KEYSTONE ELECTRONICS CORP.			
www.keyelco.com • NEW HYDE PARK NY 11040 • Tel (516)328-75			
PART NAME			
CERAMIC STANDOFF			
MATERIAL			
GRADE L5 CERAMIC			
FINISH	BOONE DATE 11.22.96		
GLAZED	APP'D RH SCALE 2 X		
TOLERANCES INCH [MM] COD	DWG NO.		
DECIMAL ± .005 [± 0.13] ANGULAR ± 1° UNLESS OTHERWISE SPECIFIED	7714

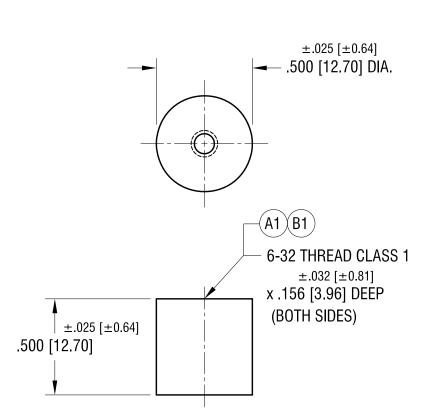
3.30.22	B1 WAS .156±.015 DEEP CHANGE AS PER ECN 22-063	В
3.11.22	HOLE DEPTH (A1) WAS .140 CHANGE AS PER ECN 22-057	А
DATE	DESCRIPTION
